This sheet transmits Revision 1 to MTB-33-01, which:

LIGHTS - REPLACEMENT OF ENTRY AND ICE LIGHT SOCKETS

MTB-33-01
Page 1 of 10

Figure 1. Ice Light and Entry Light Socket Replacement (Sheet 1)

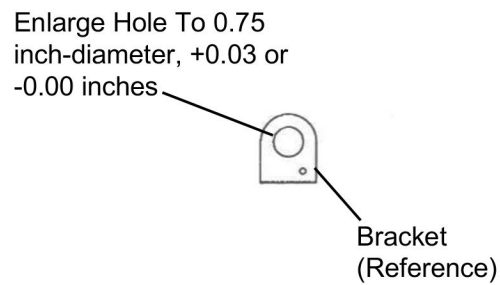
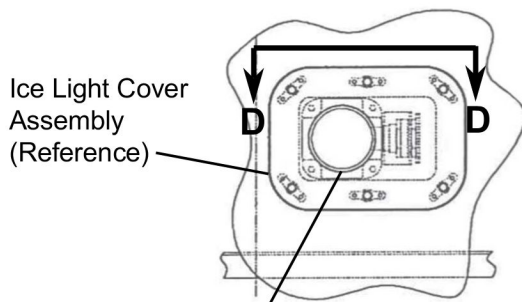
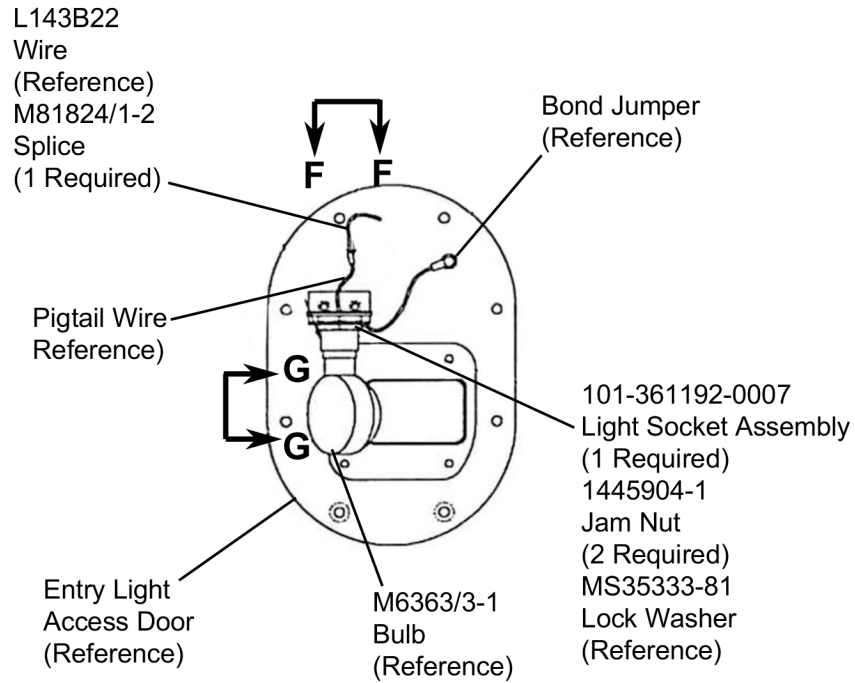
2. Install new 101-361192-0007 Ice Light Socket Assemblies.
- A. (Refer to Figure 1, View A-A and View D-D.) Modify the ice light cover assembly. (Refer to the applicable Maintenance Manual, Chapter 33, Lamp Replacement - Maintenance Practices.)

- (a) (Refer to Figure 1, View E-E.) Enlarge the 0.69 diameter hole in the bracket to 0.75 inch diameter, +0.03 or -0.00 inch.
 - (3) (Refer to Figure 1, View D-D.) Modify the wiring.

- (4) (Refer to Figure 1, View A-A and View D-D.) Install the 101-361192-0007 Light Socket Assembly.
 - (a) Put the 101-361192-0007 Light Socket Assembly in the bracket with two 1445904-1 Jam Nuts.

- (b) Install the kept A7079B-24 Bulb in the 101-361192-0007 Light Socket Assembly.
 - (c) Rotate the socket in the ice light assembly so that the A7079B-24 Bulb will illuminate the de-icing boot in the area visible to the pilot.

- (6) (Refer to Figure 1, Detail A and View A-A.) Install the modified ice light cover assembly in the nacelle using the kept hardware.
 - (7) Do Step 2.A.(1) through Step 2.A.(6) for the opposite ice light cover assembly.

Figure 1. Ice Light and Entry Light Socket Replacement (Sheet 2)

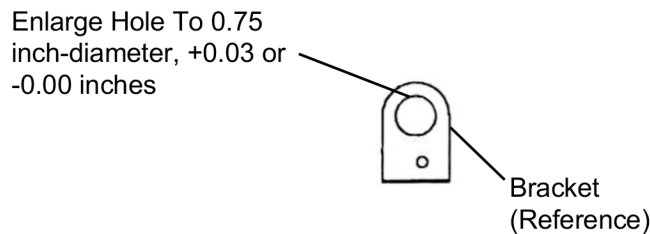
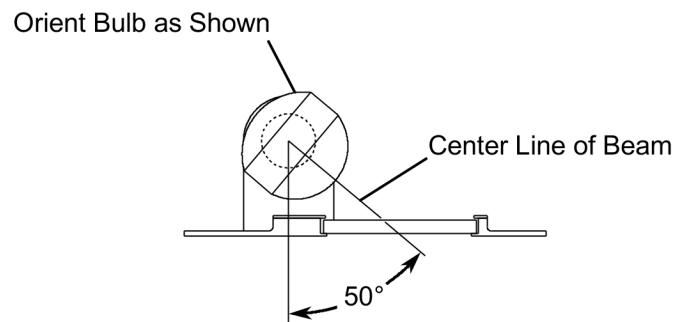
- (1) Keep the bulb and discard the socket.
- C. (Refer to Figure 1, View B-B and View F-F.) Modify the 101-360031-0001 Door Assembly.
- (1) (Refer to View E-E.) Enlarge the 0.69 inch diameter hole in the 101-360031-0005 Bracket to 0.75 inch diameter, +0.03 or -0.00 inch.

- E. (Refer to Figure 1, View B-B and View G-G.) Install the 101-361192-0007 Light Socket Assembly.
- (1) Install the 101-361192-0007 Light Socket Assembly in the 101-360031-005 Bracket with two 1445904-1 Jam Nuts.

- (2) Install the kept A7079B-24 Bulb in the 101-361192-0007 Light Socket Assembly.
- (3) (Refer to Figure 1, View G-G.) Rotate the socket in the entry light assembly so that the A7079B-24 Bulb will illuminate the ground/door stairs.

- (6) Tighten the 1445904-1 Jam Nuts.
- (7) (Refer to Figure 1, Detail A and View B-B.) Install the modified door assembly in the underside of the left wing using the kept hardware.
